SOUTHERN OAKS ESTATES SUBDIVISION,
UNIT SIX, PART B

APPLICATION NUMBER Holdover DATE May 3, 2007

DETAIL SITE PLAN

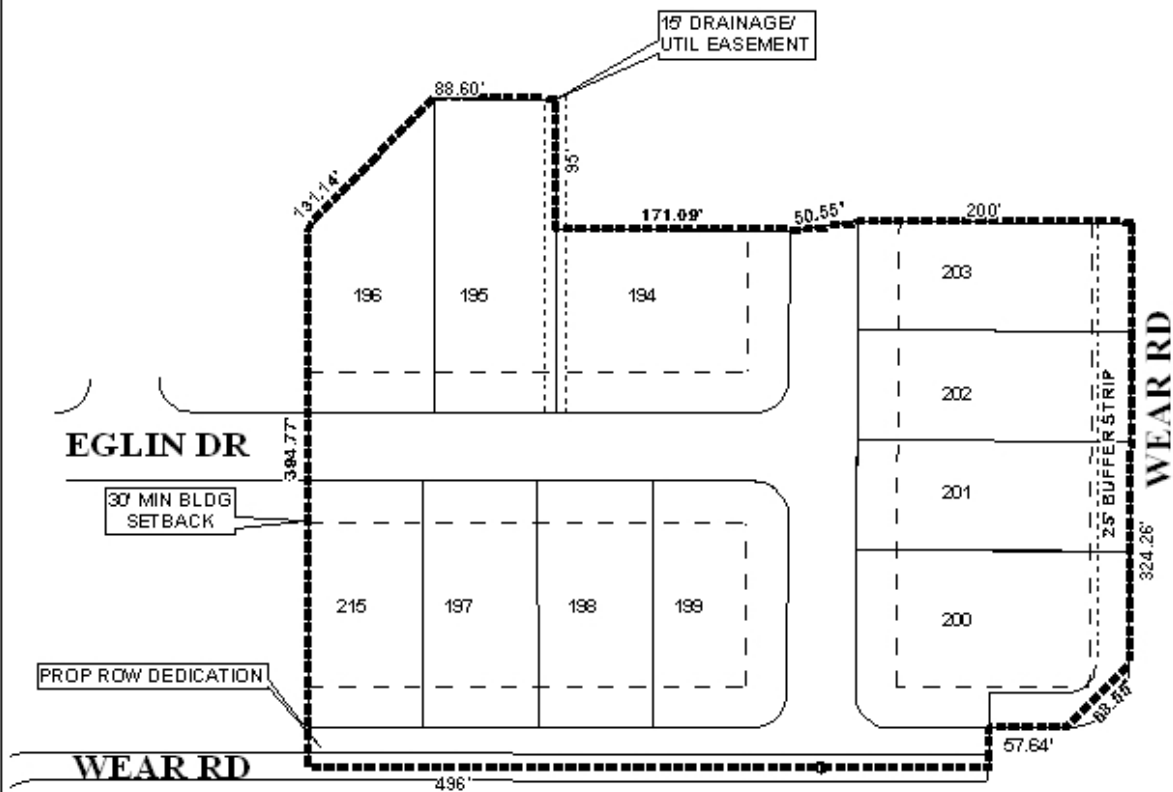
Dedication sufficient to provide 30 feet from the centerline is shown for the unpaved portion of Wear Road, as required for roads without curb and gutter; the same required for the paved portion of Wear Road, which is illustrated as providing 60-foot right-of-way. Since access from Leann Drive is proposed at Wear Road (unpaved) the provision of the construction of Wear Road (unpaved) to the westernmost arc of Leann Road to County Engineering standards should be required. The application proposes new streets, which must be constructed and dedicated to County Engineering standards prior to signing the Final Plat.

Lots 197-203 and 215 are considered double frontage lots; therefore, a waiver of Section V.D.8 would be required and a note on the Final Plat denying direct access to Wear Road. Since Lots 194, 199 & 200 are corner lots; a note should be placed on the Final Plat stating that these lots

should be restricted to one curb cut, with the size, design and location to be approved by County Engineering.

While the site is in the County, the applicant's engineer will be required to certify that the stormwater detention, drainage facilities, and release rate comply with the City of Mobile stormwater and flood control ordinances, prior to the signing and recording of the final plat, if approved. The plat should also be revised to depict lot sizes to be illustrated in square feet either through labeling or the provision of a table on the Final Plat.

Based upon the preceding, the application is recommended for Holdover until the May 3rd meeting, with revisions due by April 9th to address the following: 1) illustration of the total number of lots proposed for Southern Oaks Estates Subdivision, Unit 6, Part A; 2) dedication of sufficient right-of-way to provide 30 feet from the centerline of unpaved portion of Wear Road to the westernmost arc of Leann Drive; 3) the placement of a note on the Final Plat denying direct access to Wear Road from Lots 197-203 and 215; 4) the placement of a note on the Final Plat stating corner lots, 194, 199 and 200 are allowed one curb cut, with the size, location and design to be approved by County Engineering; 5) provision of a certification letter from a licensed engineer to the Planning Section of Urban Development, certifying that the stormwater detention, drainage facilities, and release rate comply with the City of Mobile stormwater and flood control ordinances, prior to the signing and recording of the final plat; 6) construction and dedication of the new streets to County standards; 7) placement of a note on the plat stating that any lots which are developed commercially and adjoin residentially developed property must provide a buffer, in compliance with Section V.A.7. of the Subdivision Regulations; and 8) labeling of all lots with size in square feet, or placement of a table on the plat containing the lot size information.

The plat meets the minimum requirements of the Subdivision Regulations and is recommended for Tentative Approval subject to the following conditions:

- 1) dedication of sufficient right-of-way to provide 30 feet from the centerline of unpaved portion of Wear Road to the westernmost arc of Leann Drive;*
- 2) the placement of a note on the Final Plat denying direct access to Wear Road from Lots 197-203 and 215;*
- 3) the placement of a note on the Final Plat stating corner lots, 194, 199 and 200 are allowed one curb cut, with the size, location and design to be approved by County Engineering;*
- 4) provision of a certification letter from a licensed engineer to the Planning Section of Urban Development, certifying that the stormwater detention, drainage facilities, and*

release rate comply with the City of Mobile stormwater and flood control ordinances, prior to the signing and recording of the final plat;

- 5) construction and dedication of the new streets to County standards;*
- 6) placement of a note on the plat stating that any lots which are developed commercially and adjoin residentially developed property must provide a buffer, in compliance with Section V.A.7. of the Subdivision Regulations; and*
- 7) labeling of all lots with size in square feet, or placement of a table on the plat containing the lot size information.*
